PSLR OVERLAY CONCEPT PLANS FOR:  
**PROVIDENCE MEADOWS**  
PART OF THE NORTH WEST 1/4 OF SECTION 17, T.1N, R.8E,  
CITY OF NOVI, OAKLAND COUNTY, MI

# Providence Meadows

City of Novi, Michigan  
Robertson Brothers Homes

## **PLANNING REVIEW**

Figure 1: Current Zoning

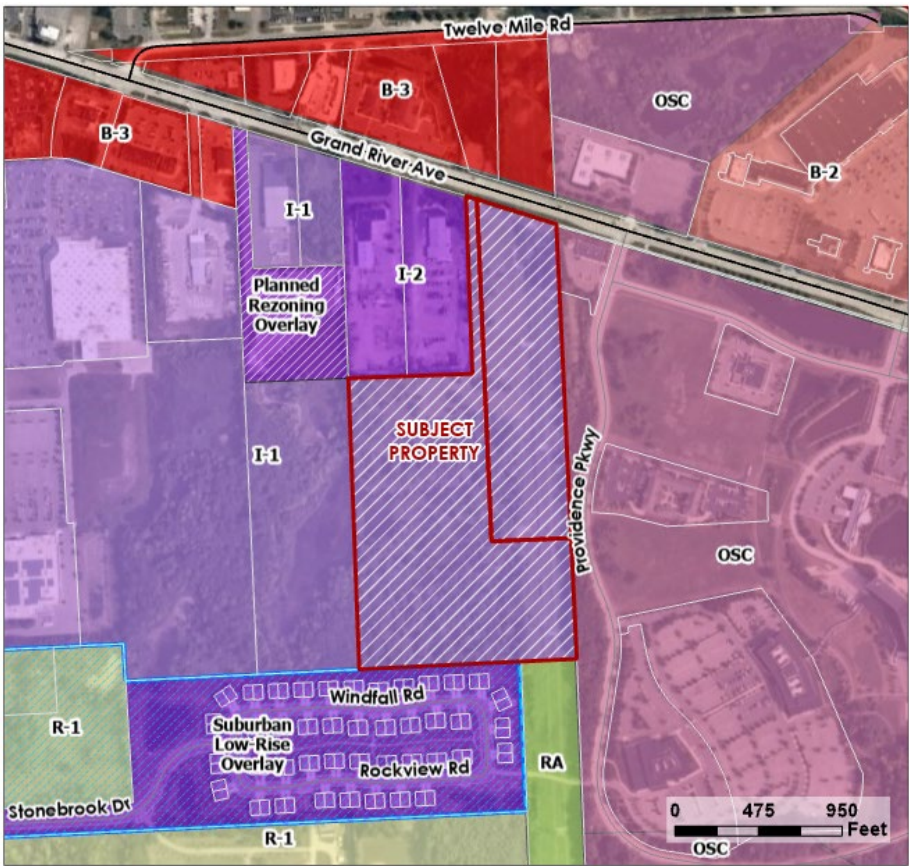
Figure 1 shows the current zoning of the subject parcel and surrounding parcels.

Figure 5: Future Land Use

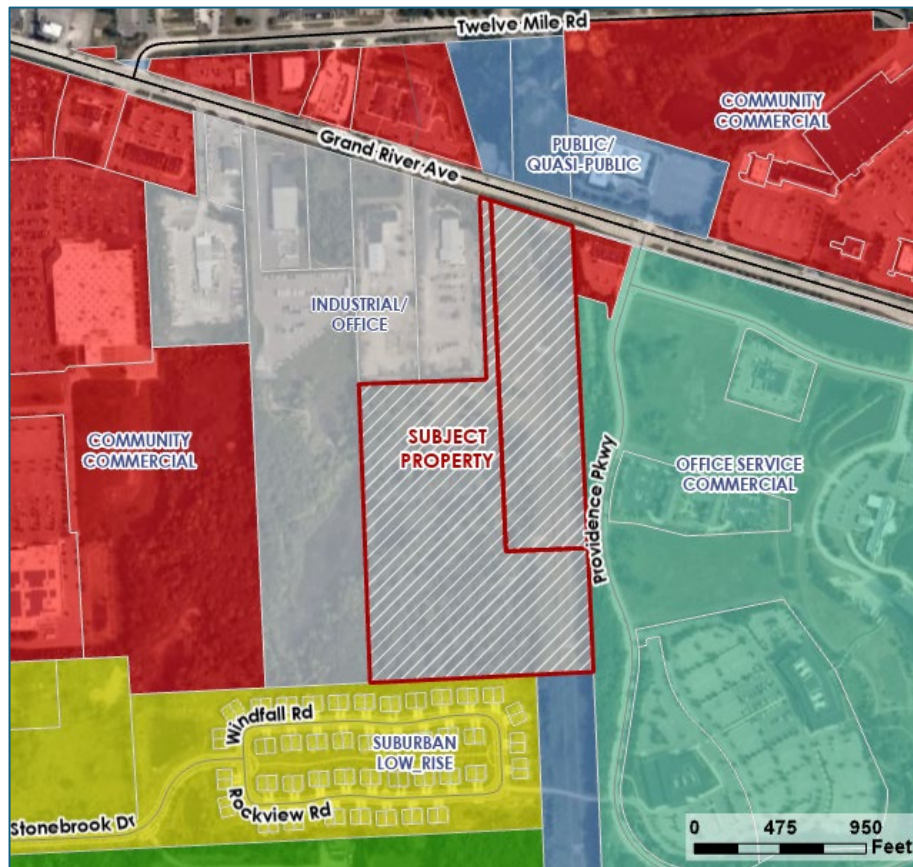
The City adopted the 2025 Master Plan in June 2025. As shown in Figure 5, the Future Land Use map designates the subject area and those to the north and west as Industrial/Office.

**Figure 1. City of Novi Regulated Woodlands Map**

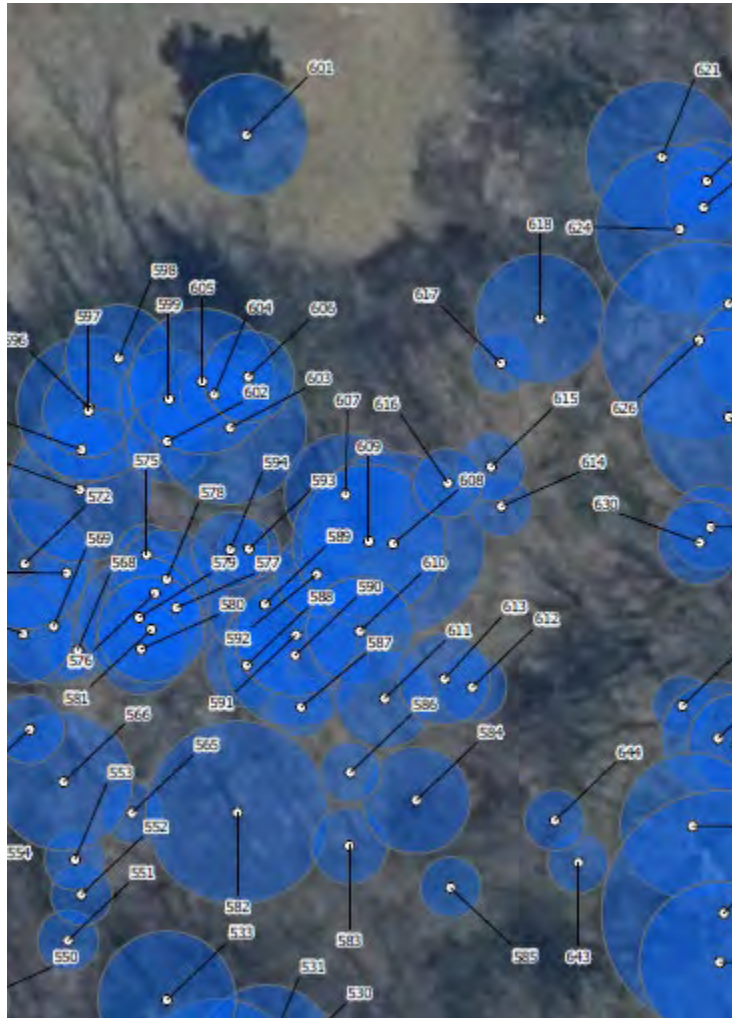
- b. An updated outline of regulated woodland areas is provided in **Figure 1** and the shapefile (.shp) was provided to the City of Novi in previous reviews and can be provided to the applicant upon request. The regulated woodland area on-site is relatively consistent with the “Tree Line” and “Heavily Wooded Area” provided on Sheet C2 in the Site Plan.

**Figure 2. City of Novi Regulated Wetlands Map**  
Approximate Site boundary is shown in Red.  
Approximate Regulated Wetland areas are shown in blue.

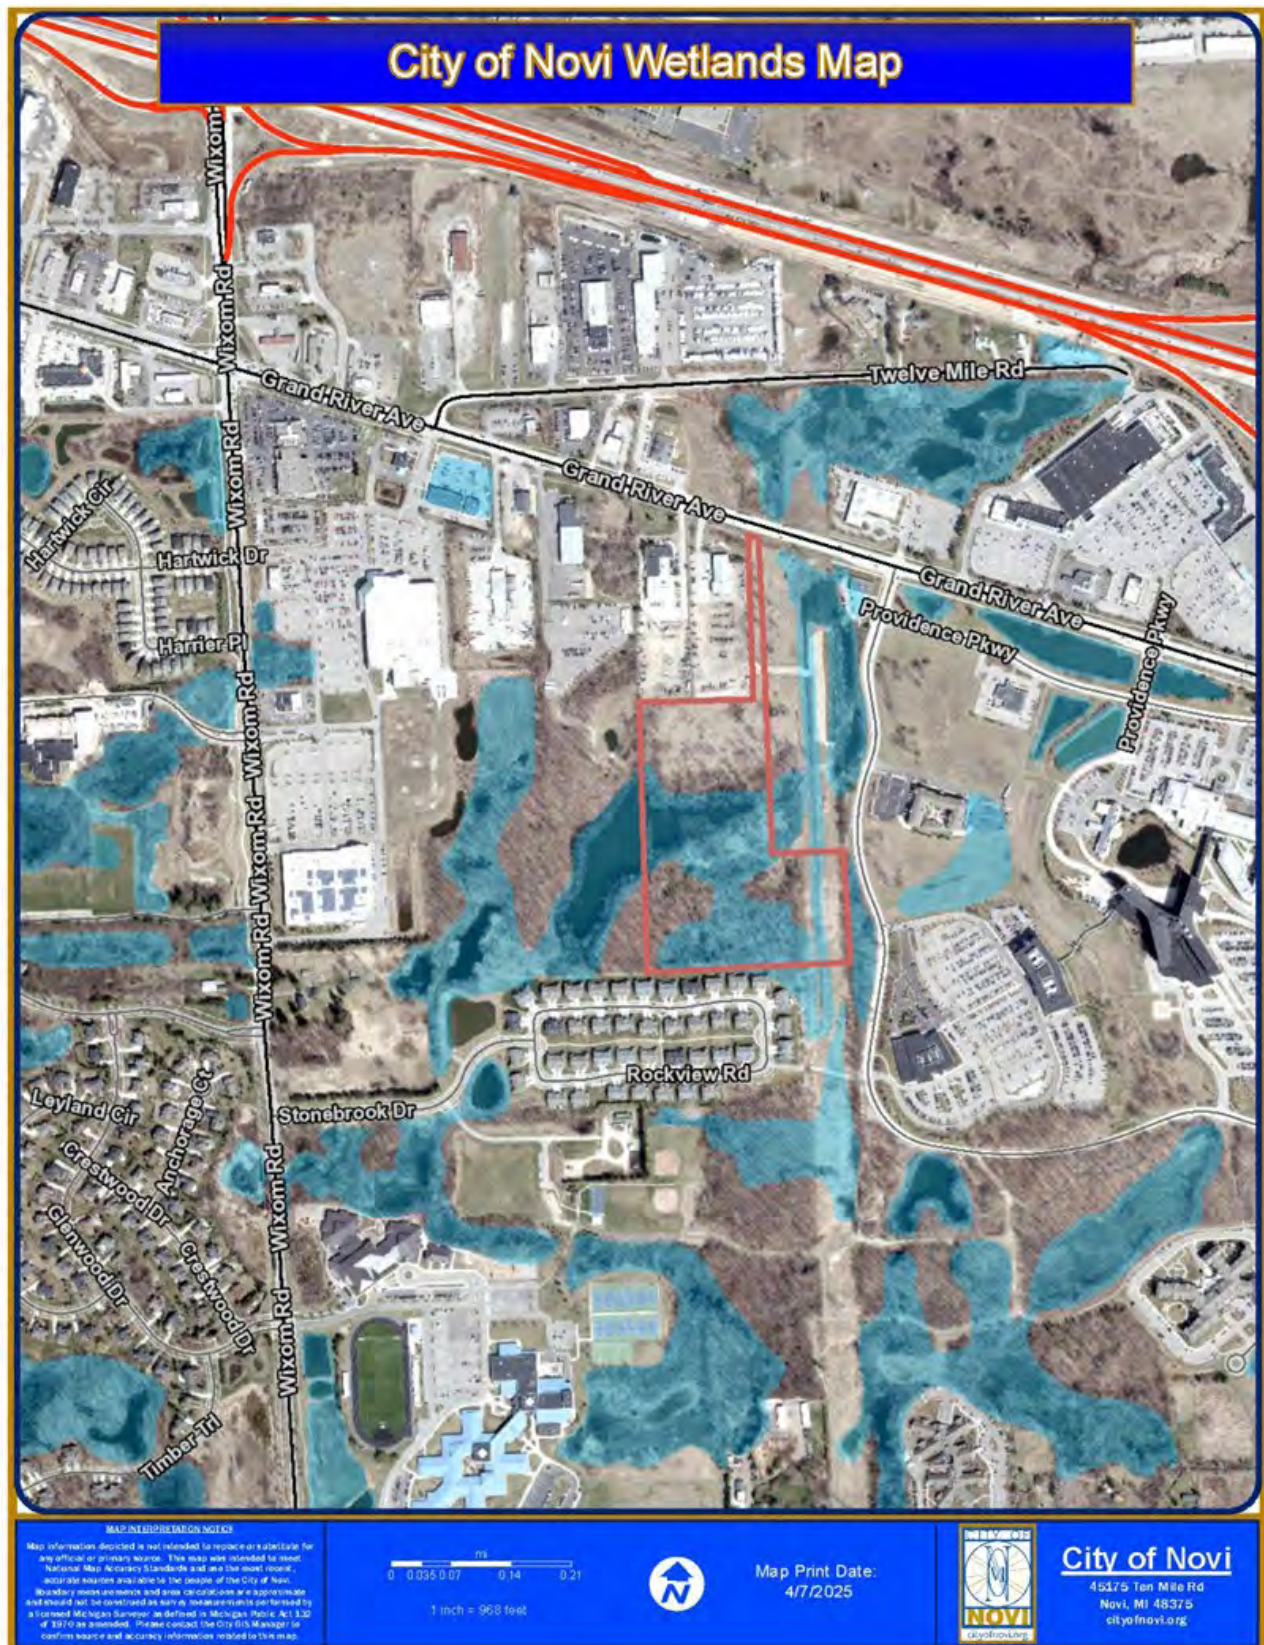
- ☒ City-regulated wetlands, as identified on the City of Novi interactive map website. Note that both wetland and property limits depicted on the City's map are considered approximations (**Figure 2**).
- ☒ Wetlands that are regulated by the Michigan Department of Environment, Great Lakes, and Energy (EGLE).
- ☒ Wetlands as identified on National Wetland Inventory (NWI) and Michigan Resource Inventory System (MIRIS) maps, as identified on the EGLE Wetlands Viewer interactive map website (provided
